COMMERCIAL AVENUE SANITARY SEWER RECONSTRUCTION

CITY PROJECT NO. 14921
CONTRACT NO. 9486

ADDENDUM #3: 9/3/2024
 1. REMOVED AND REPLACED FOLLOWING SHEETS: TITLE, D-2, EC-1-EC-6, U-1-U-8. ADDED SHEETS EC-3A, EC-3B, U-3A, U-3B

REVISION #1: 10/14/2024
 1. ADDENDUM #3 MARKUPS HIDDEN ON PLANS (ALL SHEETS)
 2. UNMARKED ATC FIBER ON COMMERCIAL AVE. (SOUTH) ADDED WITH ADDITIONAL ULOS (EC-3B, EC-5, U-3B, & U-5)

14921	MADISON, WI	9486
SEWER PLAN AND PROFILE - PROPOSED HWY 30 CROSSING		
COMMERCIAL AVENUE SANITARY SEWER RECONSTRUCTION		
M:\DESIGN\Projects\14921\CAD\Sewers\14921SWR-ErosionControl.dwg		
14921	EC-3B

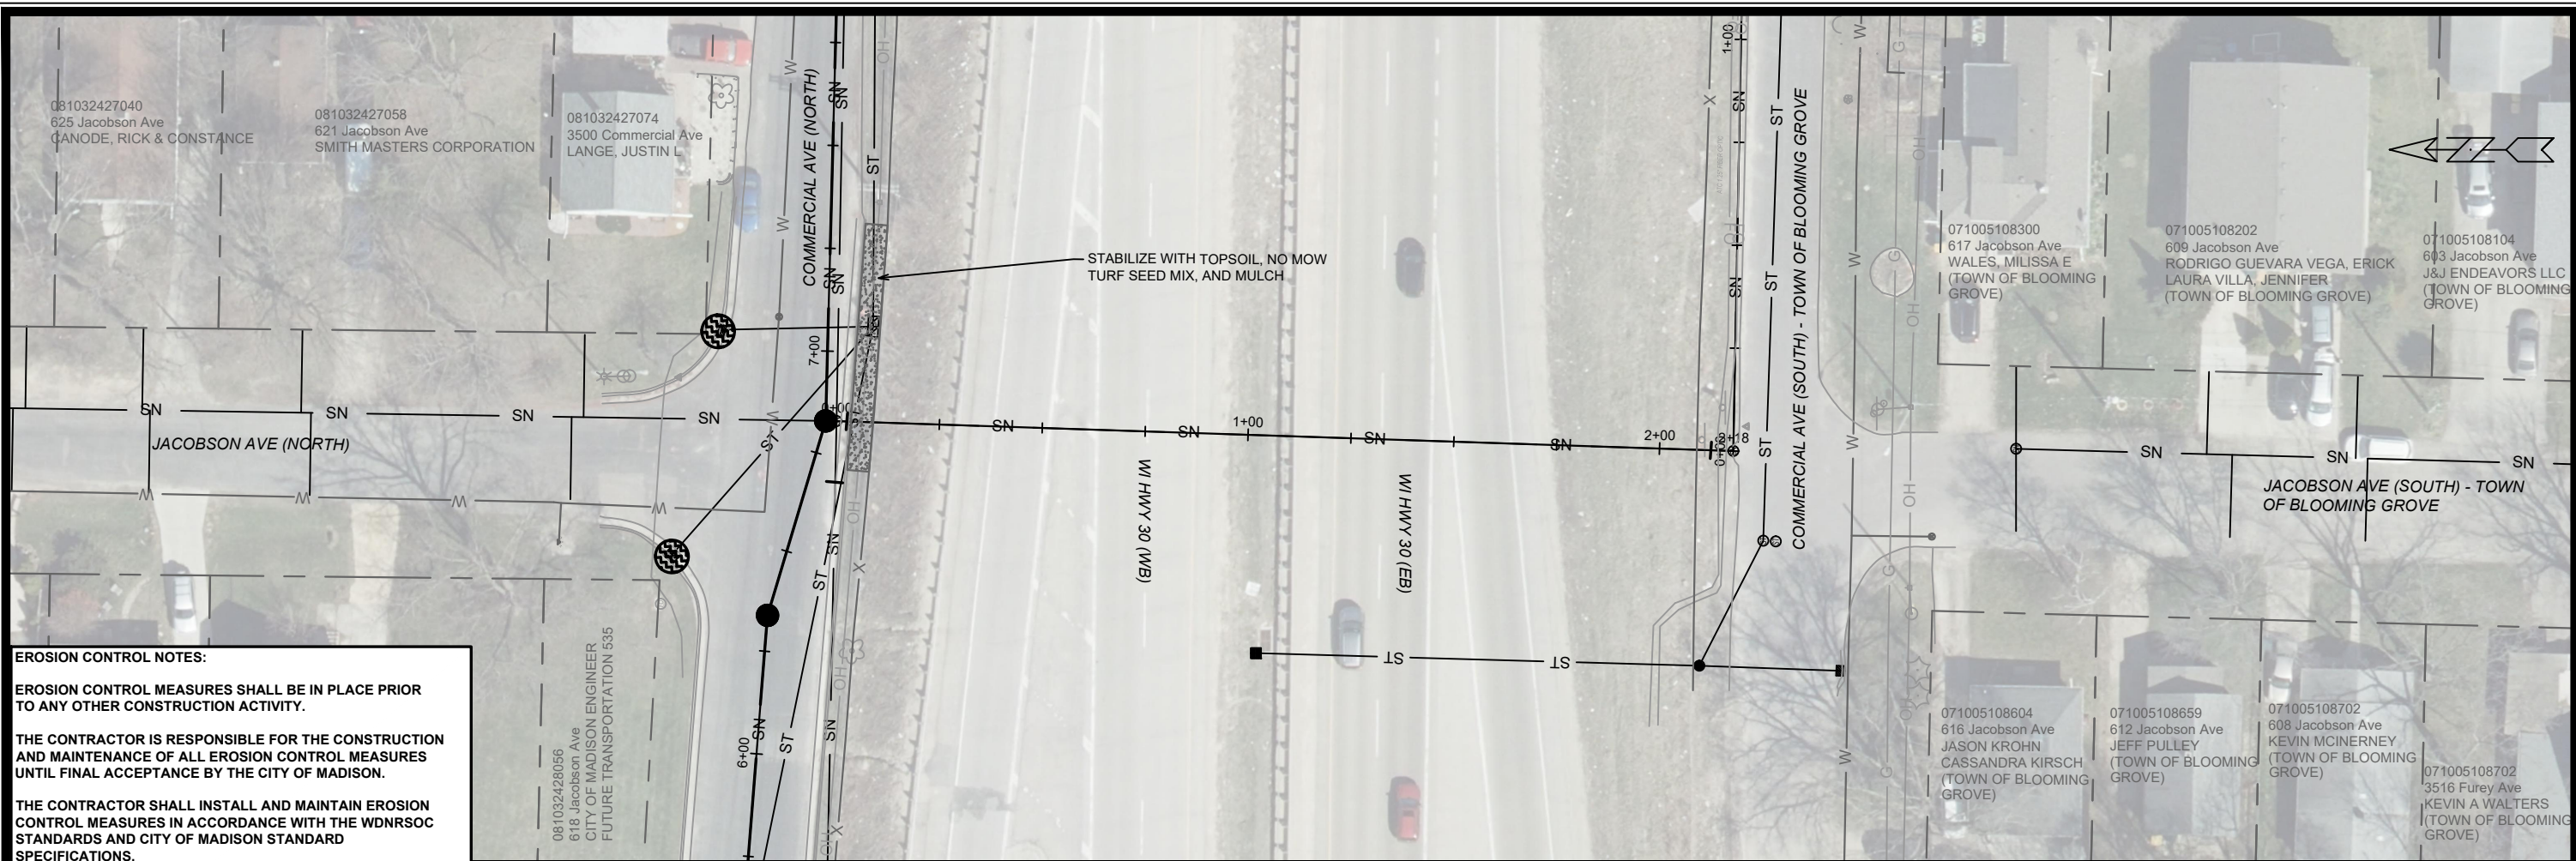
2. UNMARKED ATC FIBER ON COMMERCIAL AVE. (SOUTH) ADDED WITH ADDITIONAL ULOS (EC-3B & EC-5)

MARK	REVISION	DATE	BY
1	PAST MARKUP REMOVAL, ATC FIBER	10/14/24	EAC
Designed By: EAC		Date: 10/14/2024 2:18 PM	Scale: 1" = 40'
14921		EC-5

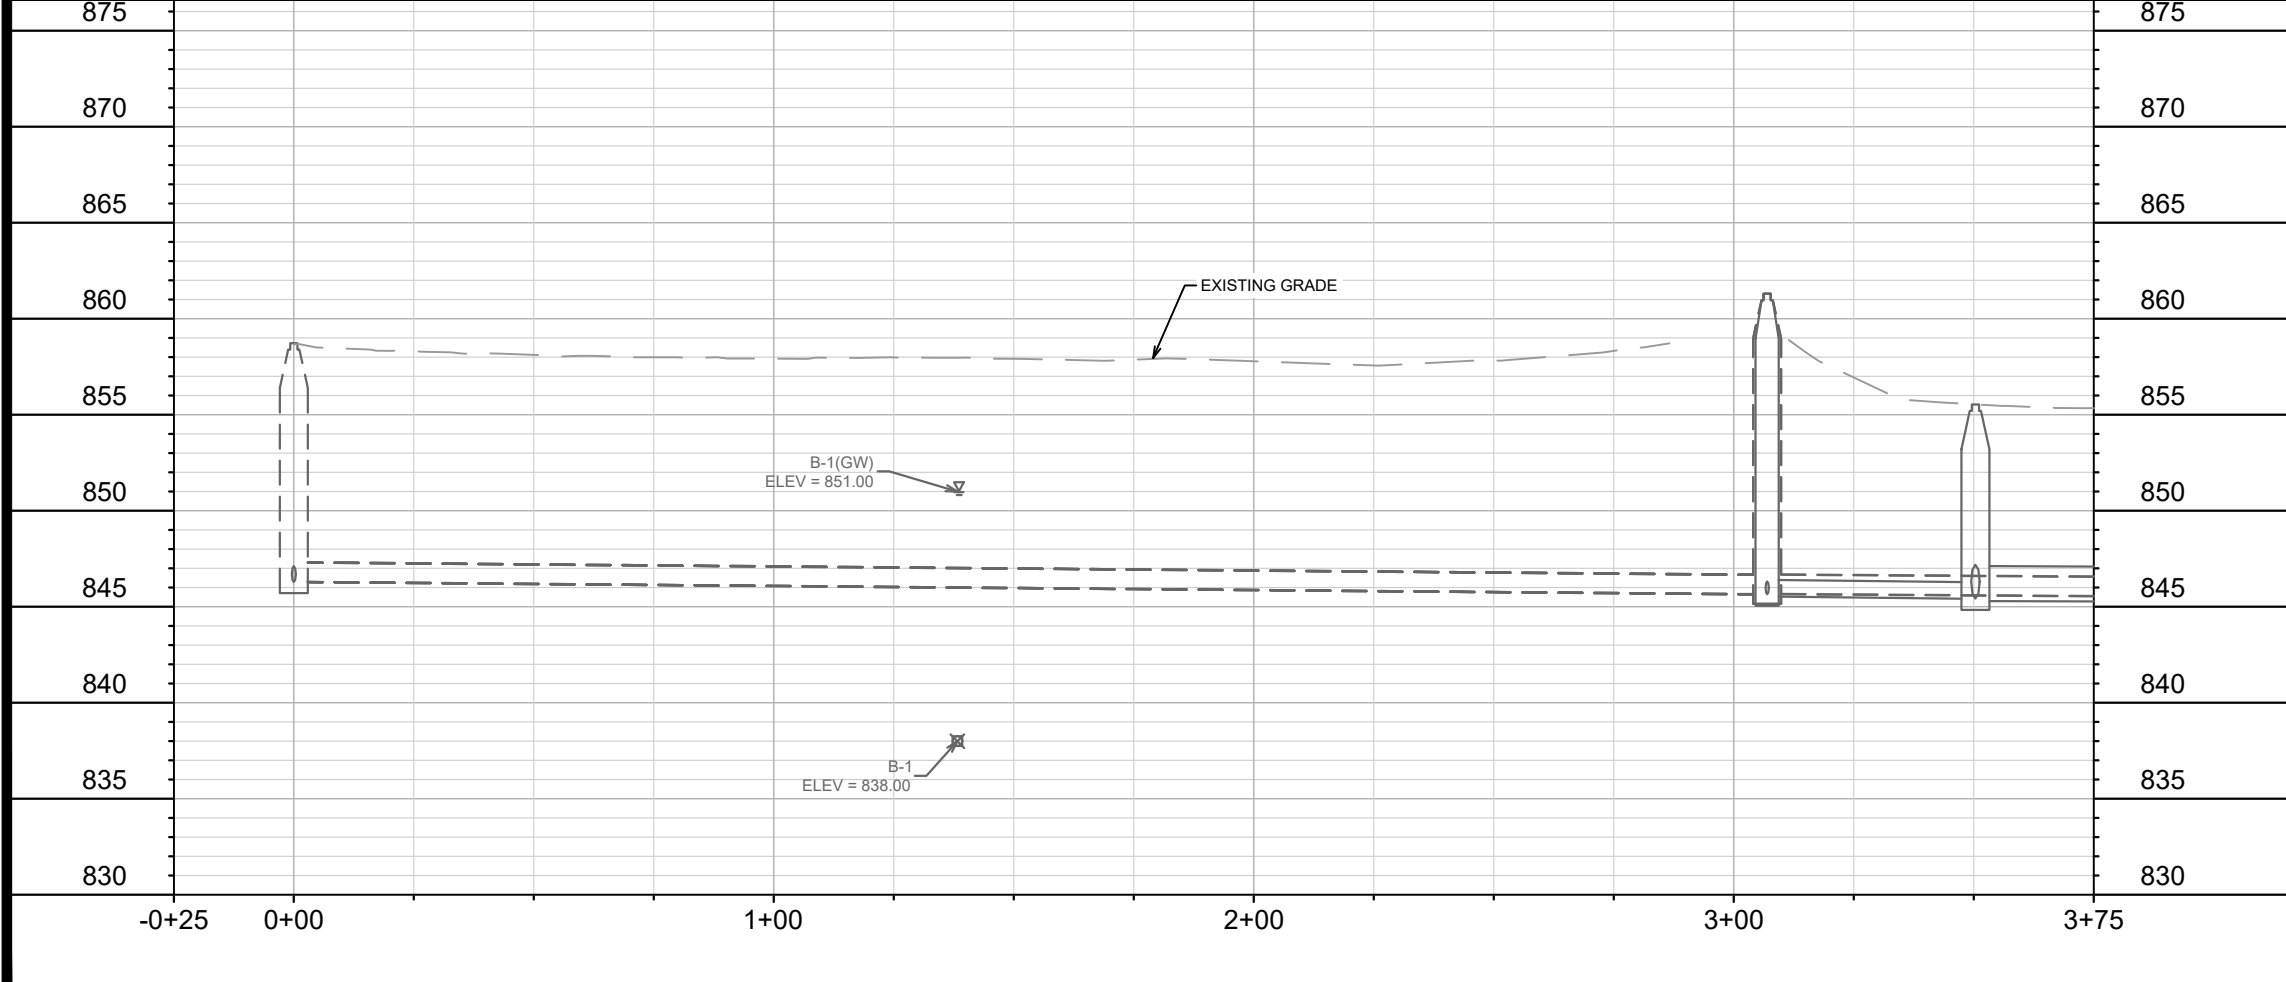
2. UNMARKED ATC FIBER ON COMMERCIAL AVE. (SOUTH) ADDED WITH ADDITIONAL ULOS (EC-3B & EC-5)

14921	MADISON, WI	9486	U-3B
SEWER PLAN AND PROFILE - PROPOSED HWY 30 CROSSING		CONTRACT NO.:	
COMMERCIAL AVENUE SANITARY SEWER RECONSTRUCTION		14921	
M:\DESIGN\Projects\14921\CAD\Sewers\14921SWR-PipeNetwork.dwg		U-3B	
14921		U-3B

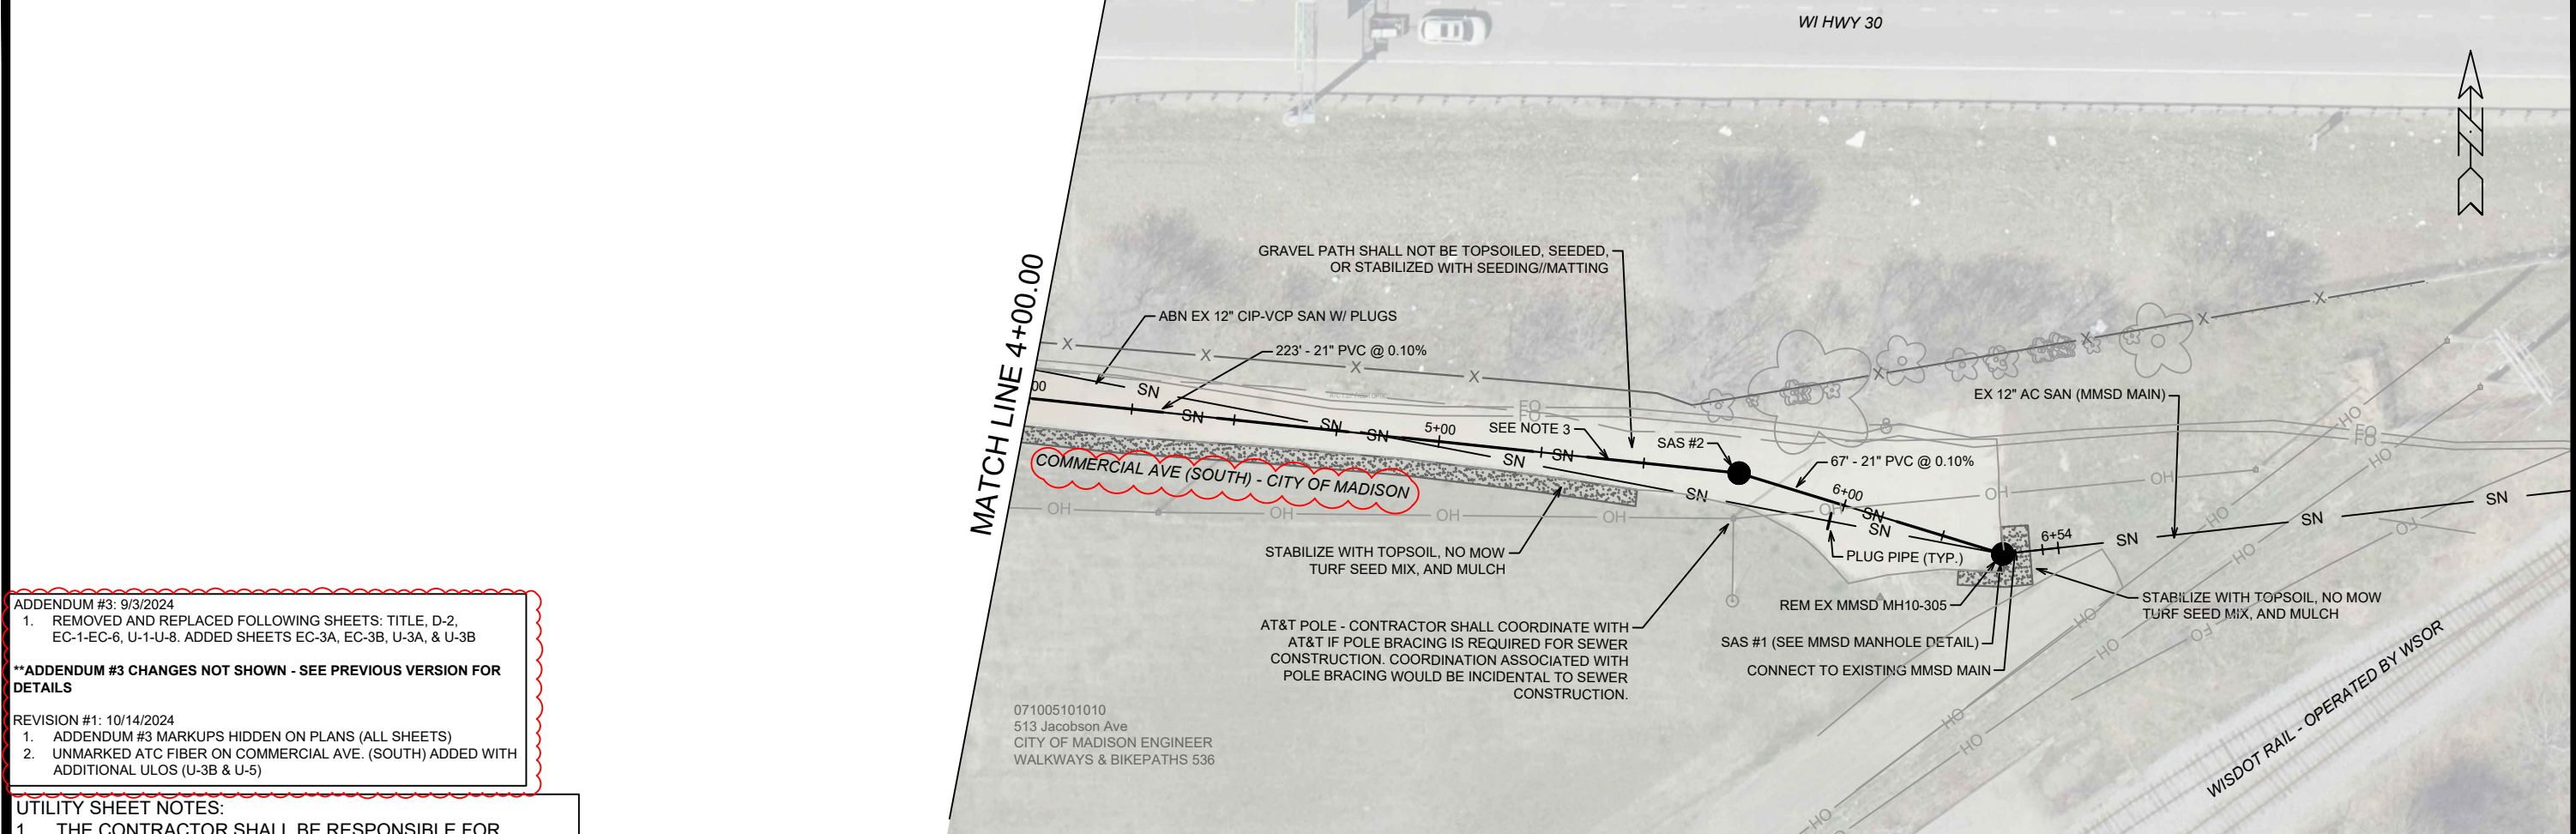
REVISION #1: 10/14/2024
 1. ADDENDUM #3 MARKUPS HIDDEN ON PLANS (ALL SHEETS)
 2. UNMARKED ATC FIBER ON COMMERCIAL AVE. (SOUTH) ADDED WITH ADDITIONAL ULOS (U-3B & U-5)
